Paddock Wood Town Council
Matter 15 – The Natural Environment (Policies EN9, EN10, EN12, EN13, EN14, EN20, EN22, EN23, EN24, EN25, EN26, EN27 and EN28)

ISSUE 3 – Biomass and Renewable Technology

APPENDIX A: PADDOCK WOOD TOWN COUNCIL REGULATION 18 LOCAL PLAN REPRESENTATIONS

RESPONSE TO THE TUNBRIDGE WELLS BOROUGH LOCAL PLAN (REG. 18)

Figure 2-2: Flood risk and the preparation of Local Plans

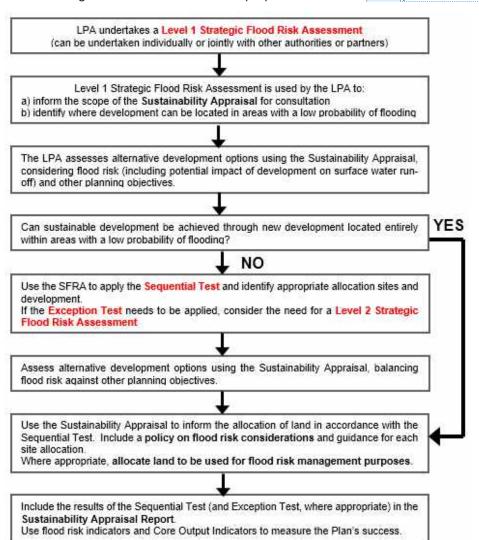
Commented [PW58]: 1). Second box down. "Identify where development can be located in areas with a low probability of flooding". Most of the areas in the draft Local Plan in Paddock Wood are zones two and three – intermediate and high.

Figure 2-3: Strategic planning links and key documents for flood risk

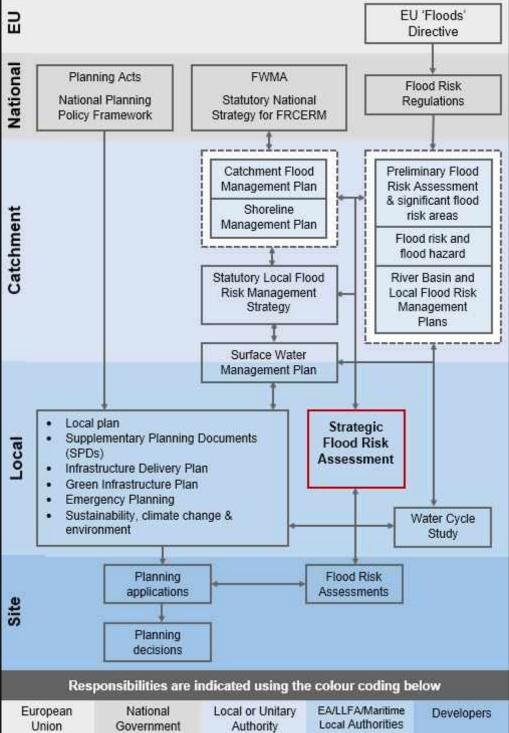
Commented [PW75]: IDB's also have their own consenting system for all watercourses within their Internal Drainage District. In Tun Wells Borough, they are only classified as a neighbour and NOT a statutory consultee in the planning process, which in the opinion of PWTC, they should be.

Figure 6-4: Historical flood records across Tunbridge Wells Borough

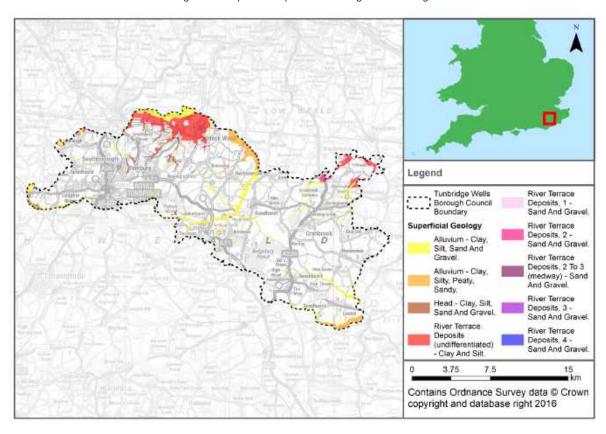
Commented [PW155]: Figure 6.4 shows no detail – i.e. coloured dots in Paddock Wood. Against PWTC and others' records, this is wrong.

Figure 6-6: Areas of risk of reservoir flooding following a breach or failure

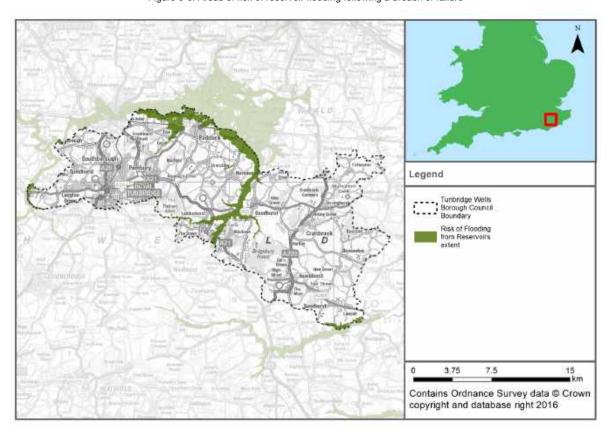
Commented [PW180]: Figure 6-6 shows areas north of railway from Capel East (Brook Farm) towards the Hop Farm roundabout that would be inundated if built upon. Surely this excludes them from ANY development?

Figure 7-4: Location of defences near Woodgate Way

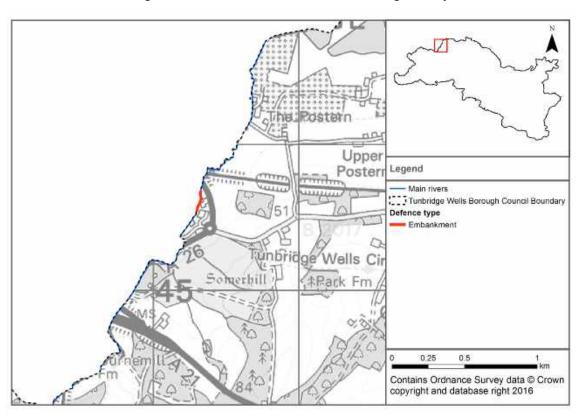
Commented [PW188]: Probably to defend the new houses behind the Porsche garage. Are the property owners aware they have to maintain it ultimately?

Figure 7-7: Location of defences at Five Oak Green

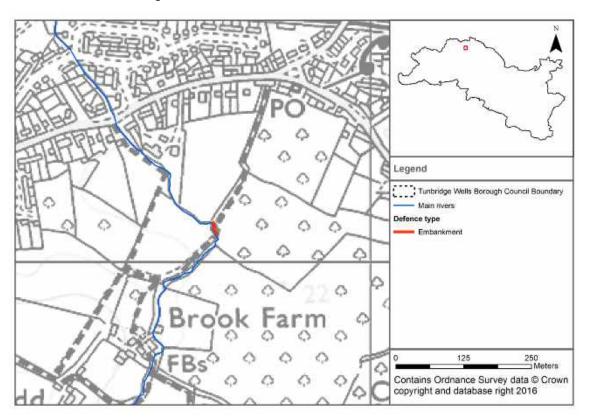
Commented [PW189]: TWBC?
